**Golder Associates Inc.**

June 1995

**THIRD PARTY REVIEW  
OF PROCEDURES AND INTERPRETATION  
OF AIR INJECTION PERMEABILITY TESTS**

**DRAFT**

FIGURE 1

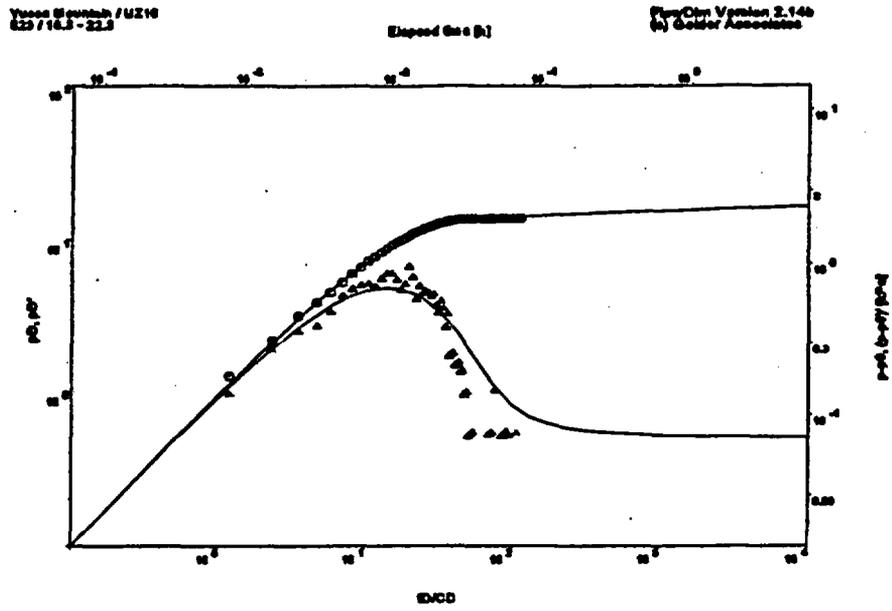
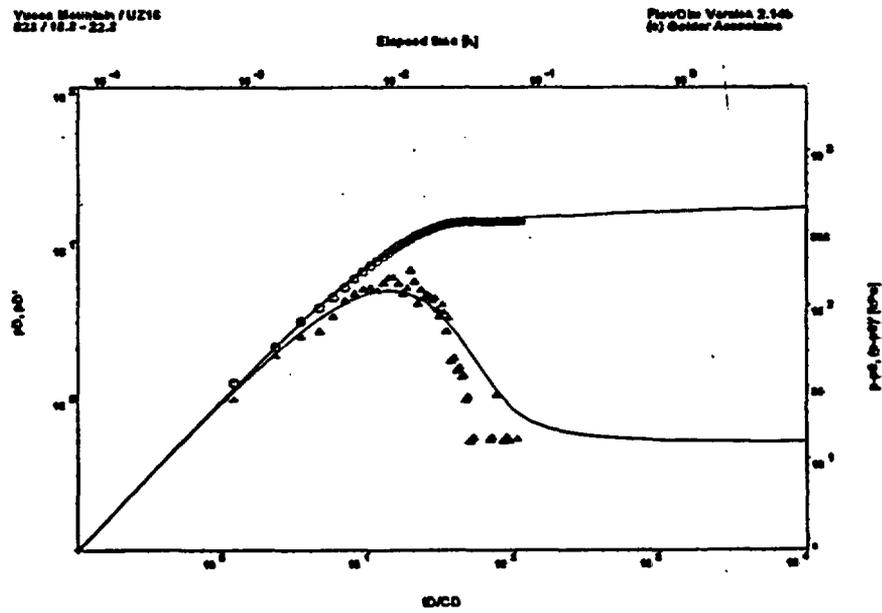
Figure 1(b) shows the type-curve analysis for the same test (60' - 73'; Tiva Canyon) using  $p^2$  as the dependent variable. The overall match is not significantly better than that obtained with the p-

based approach. It seems that for the pressure disturbance imposed during this test either linearization approach is equally valid. As pointed out earlier, although the "pressure" versus time curve seems to match closely the type curve, the pressure derivative clearly shows the discrepancy and the lack of match between the data and the radial flow model. A type-curve match for the same data and the spherical flow model is presented in Figure 2. The match for both the pressure and pressure derivative are superior with this model. One must admit, however, that a slightly longer test would have provided the necessary evidence to categorically reject the radial model. In fact, this is the case for the test with a higher flow rate in the same location (Figure 3). In this instance, the radial flow model can be categorically discarded because enough data was collected beyond the point where pressure stabilization for such model is expected (notice the flattening of the type curve at  $p_D = 0.5$  in Figure 3a). Indeed, Figure 3(b) shows a very good match between the data and the spherical flow model. Estimated permeability values and skin factors for all these tests are reported in Table 1. Notice that the reported skin values for the spherical flow model are much smaller than those from the radial flow model, and much more smaller than those reported by ARI.

FIGURE 2

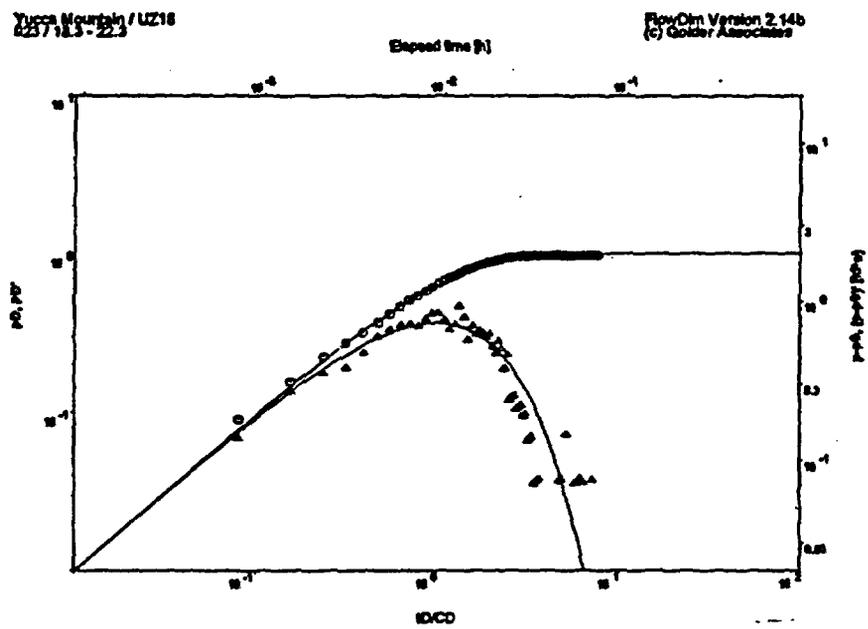
The test interpretation performed by ARI resulted in permeability values and skin parameters which are generally much larger than those estimated by the USGS. For instance, air permeability for the test in the Tiva Canyon member at a depth between 60' to 73' (Figure 2, from ARI 1994) is 210 Darcies with a skin factor of 135, whereas the USGS permeability estimate is 2.1 Darcies. In order to study such a large discrepancy, we re-interpreted the same test using the FLOWDIM code. Figure 1(a) shows the field data and the corresponding type curves for the radial flow case. Notice that the match between the derivative data is relatively poor for "late" times within the test, just as that shown in Figure 2 from ARI (1994). However, the estimated permeability and skin factor are different to those reported by ARI (see Table 1). Our estimates are 21 Darcies and 8.1 for permeability and skin respectively. It must be noted that we used the same porosity, average fluid compressibility, air viscosity, temperature and gas deviation factor as reported by ARI (page 4 in their 1994 report). When the ARI estimated values for dimensionless compressibility and skin are substituted to compute the type curve parameter  $C_e e^{2s}$ , one obtains a value of  $10^{120}$ ! This value is far beyond the typical maximum value ( $10^{30}$ ) reported in the oil and gas literature (see for example Bourdet et al., 1983). Our best match in Figure 1(a) is obtained with a  $C_e e^{2s}$  of  $10^{10}$ . It is interesting to notice that all  $C_e e^{2s}$  values computed from ARI's 1994 report are between  $10^{60}$  and  $10^{200}$  with the majority over  $10^{100}$ .

FIGURE 3

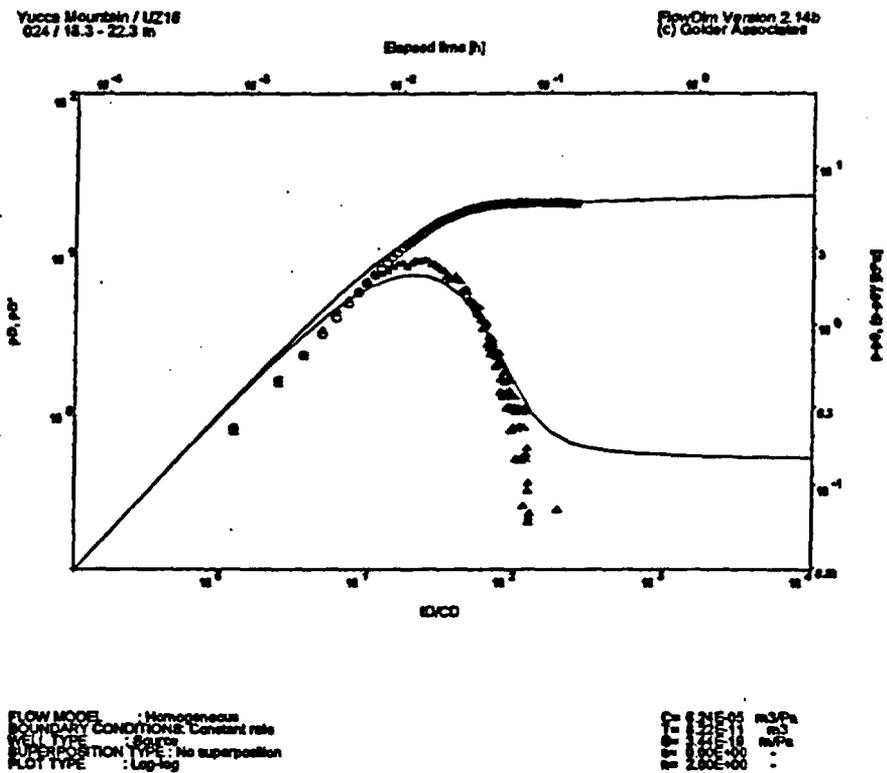
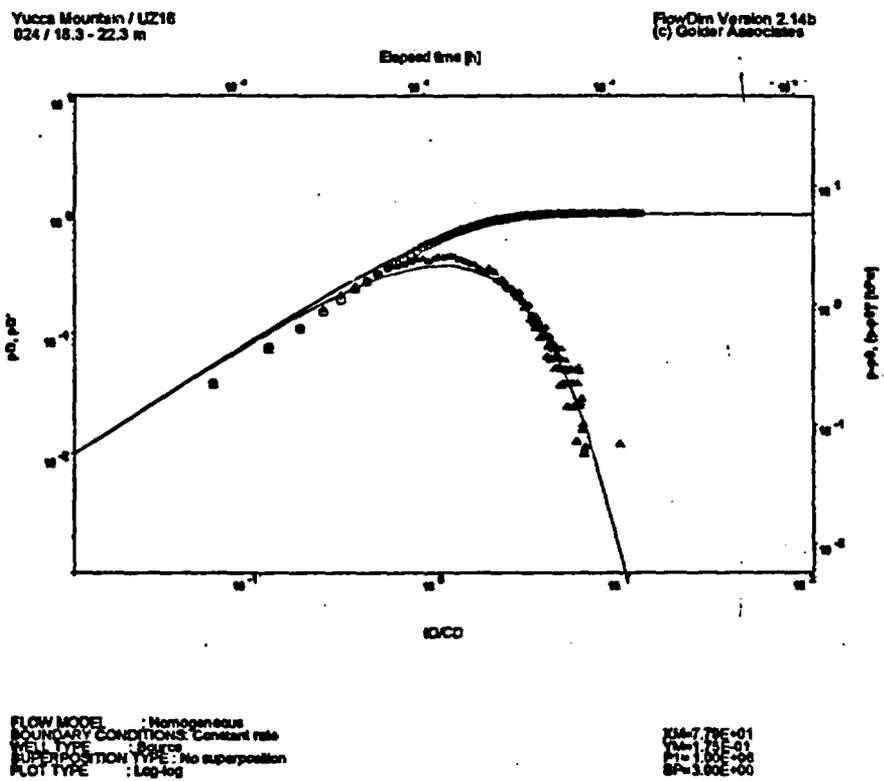
One other test (UZ-16-075) between depths 177.1 and 181.1 m was analyzed with FLOWDIM. Figure 4(a) shows the radial flow type curve match, whereas Figure 4(b) shows the spherical flow type curve. From figure 4(a), one can discard radial flow as an option for interpreting this test. Once the derivative decreases sharply beyond 0.5, the radial flow model is not a candidate anymore. Figure 4(b) shows a nice fit to both the pressure and the derivative data. The skin factor for these models are 32.3 and -0.35 for the radial and the spherical model, respectively. These latter values clearly illustrate the concept of pseudo-skin in the case when the wrong model is selected.
